Preservation Department – Item 2, LPC-23-02975

**112 2nd Avenue – East Village/Lower East Side Historic District
Borough of Manhattan**

SUPPLEMENTAL PRESENTATION IN SUPPORT OF MCC APPLICATION

**Supplemental Statement
in support of the
Middle Collegiate Church
Application for a Certificate of Appropriateness
December 12, 2022**

NORTH TOWER MASONRY – POST FIRE CONDITION - ENLARGED

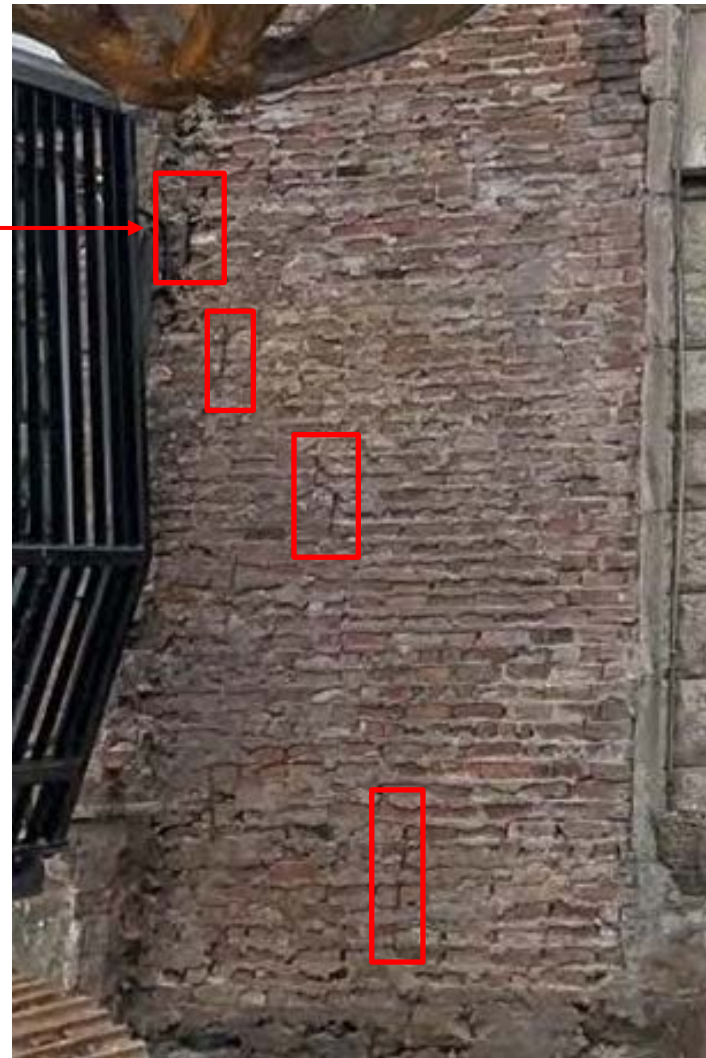
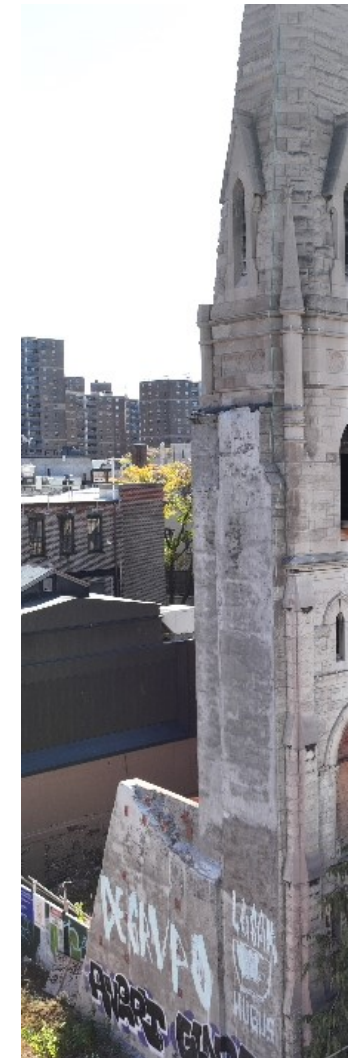
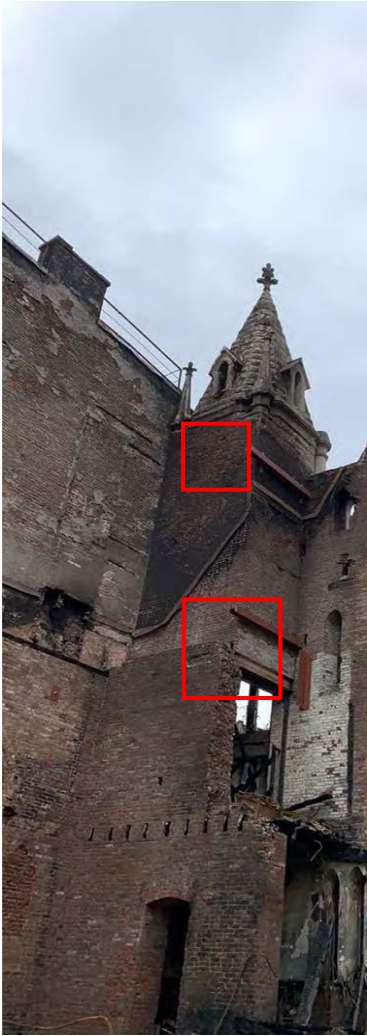
There is a visible masonry crack at the steel transfer beam on the south tower. There are cracks in the east face of the north tower. There are cracks in the masonry on the north face of the north tower. See supplemental slides R-3, 5, 7 and 9.

-  35 BRICKS WITHOUT VISIBLE SURFACE DAMAGE
-  386 DAMAGED BRICKS
- 88% DAMAGED BRICKS

IMAGE IS APPROXIMATELY 15% OF TOWER FACE

R-11

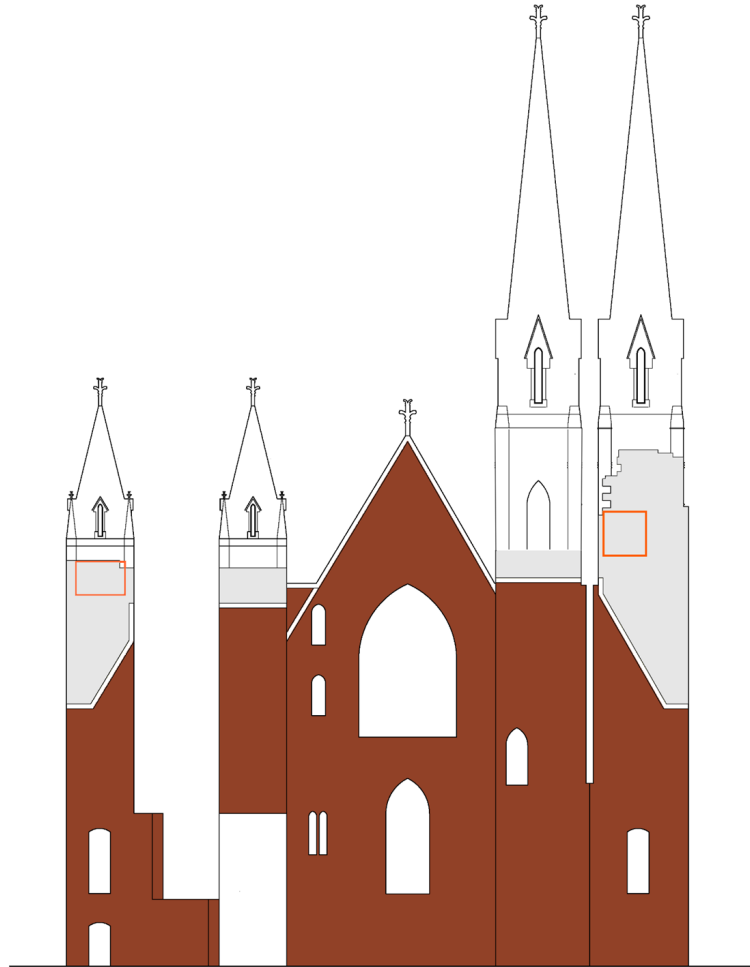
“In 2020, a devastating fire damaged the church such that the only remaining parts of the structure are the east (rear) wall...” pP.1.

This is factually incorrect. The east/rear wall did not remain after the fire. The wall was extensively damaged and was ordered demolished by DOB. What is visible today was installed after the fire. See, supplemental slide R-10.

The damage suffered by the rear wall brick was substantially the same as that suffered by the brick backing the front limestone façade (If anything, the forward brick was subject to greater damage, as noted in the Report). The owner’s rep was advised by DOB at the time that the same direction to demolish the front façade was not issued only after consultation with LPC staff, solely to give LPC the opportunity to assess the architectural features. DOB did not state that the front façade was in better condition than the east wall. To the contrary, it ordered that it be made safe, which was accomplished by the steel bracing and the berm to hold up the foundation wall.

DEMOLITION SEQUENCE

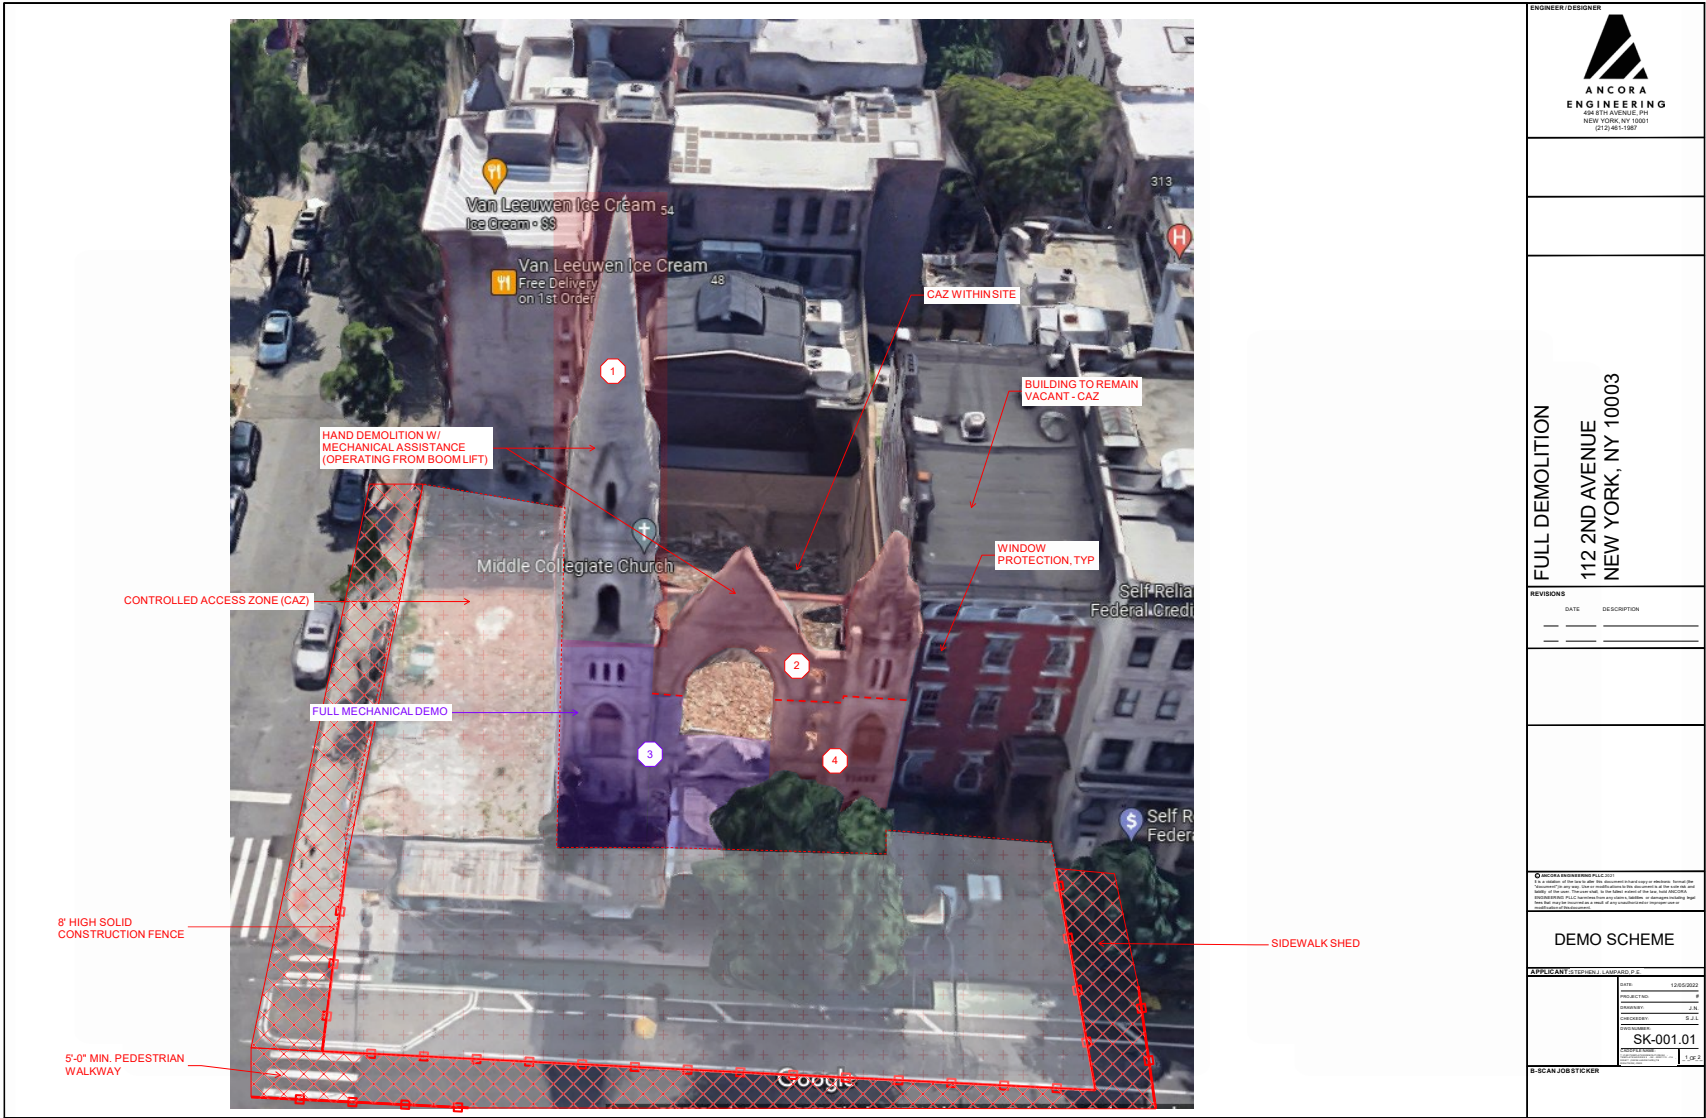
be easier than maintaining it. This topic needs to be given more consideration by the Owner's team." P. 8

“b) There was discussion of "pushing the building over". This is not mentioned clearly in the Applicant's report documentation. How will the high structure be demolished? Will scaffolding be needed? Street closures on 2nd Avenue? What other challenges?”

The demolition sequence would commence with the highest danger and remove that, then the next highest point based on what was observed, and then moving to the next segment. See supplemental slides R-17 and 18 for the demolition sequence

See supplemental slides R-17 and 18 showing hand removal to a safe height, then mechanical demolition, and where controlled access zones would be established, per the Building Code. .

REBUILT SANCTUARY WITH PROPOSED EGRESS

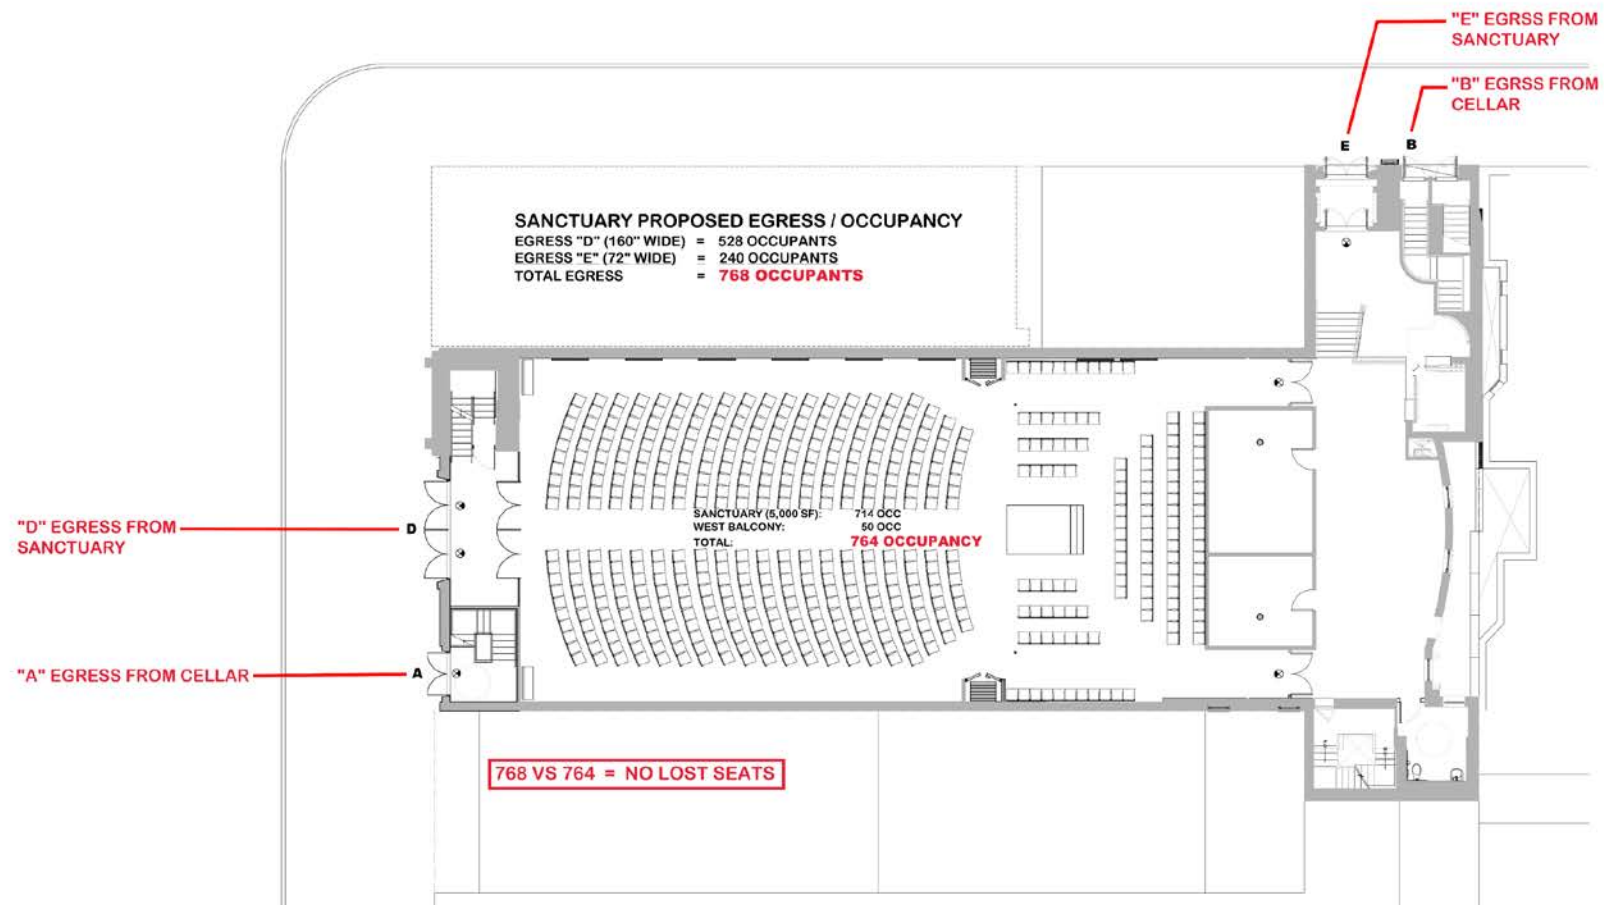
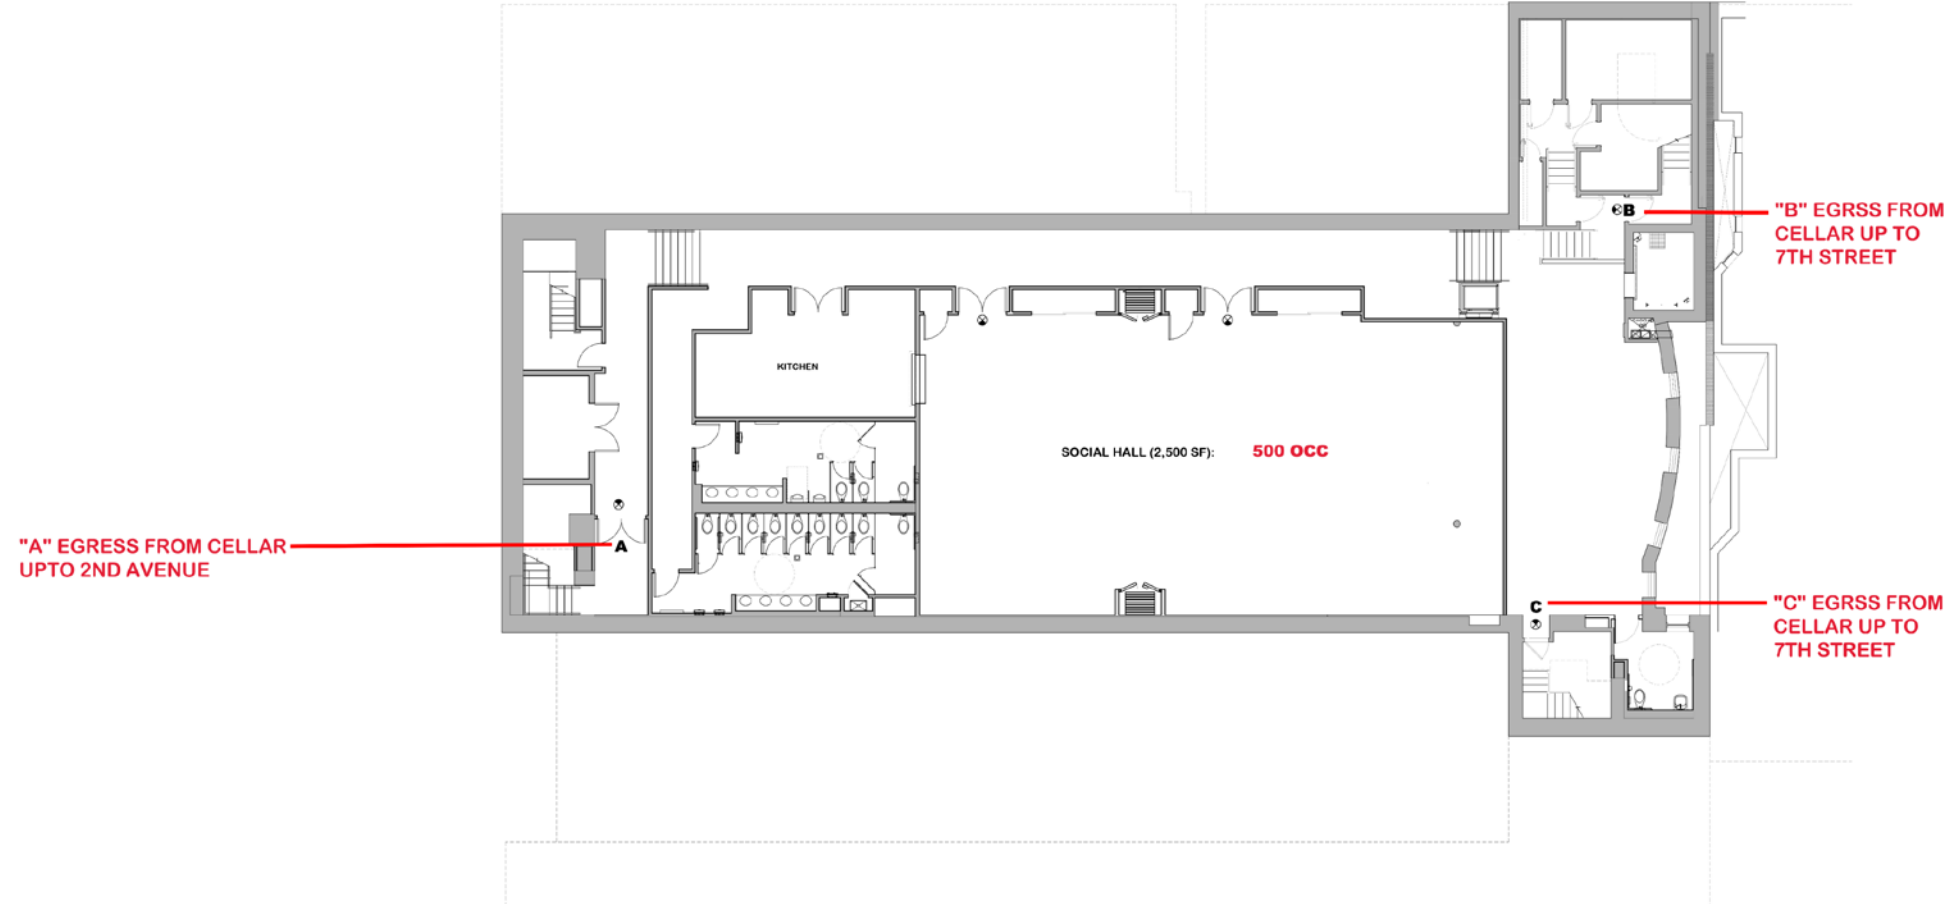
“If the new 2022 NYC Building code must be applied to this structure, special care would need to be applied to determine what items may be waived by LPC and DOB for the historic structure to create compliance with the new Code...Egress requirements must be reviewed and studied. Some of these may be required for equipment access anyway and can be addressed then.”
P. 7

EGRESS "A" (42" WIDE) = 140 OCCUPANTS
 EGRESS "B" (36" WIDE) = 120 OCCUPANTS
 EGRESS "C" (36" WIDE) = 120 OCCUPANTS
 TOTAL EGRESS = **380 OCCUPANTS**

EGRESS "A" (80" WIDE) = 264 OCCUPANTS
 EGRESS "B" (36" WIDE) = 120 OCCUPANTS
 EGRESS "C" (36" WIDE) = 120 OCCUPANTS
 TOTAL EGRESS = **504 OCCUPANTS**

We are aware of no provision in the Building Code that allows waiver of life/safety egress requirements and none has been provided to us since this was stated this at the public hearing.
